## S&S Worldwide service bulletin – restraint upgrade

|  | <b>Issuing Entity:</b><br>S&S Worldwide<br>350 West 2500 North<br>Logan, UT 84341<br>United States<br><br>P: +1-435-752-1987   F: +1-435-752-1948<br><a href="http://www.engineeringexcitement.com">www.engineeringexcitement.com</a> | <b>Bulletin No.:</b> 200117      |

## Service Bulletin

**Abstract Of Issue:** Tower Restraint Upgrade

**Option 2** - Remove single hydraulic restraint and replace with dual mechanical bumpy rod restraint.

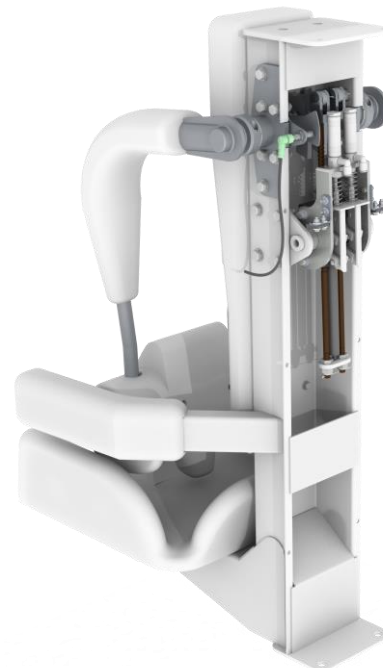
- Second restraint mechanism for redundancy.
- Proven mechanical bumpy rod system replaces hydraulic system.
- Ability to measure minimum closed position locking of restraint pawl.
- Rework tower components as lower cost option.
- Keeps floating ride experience for passengers.
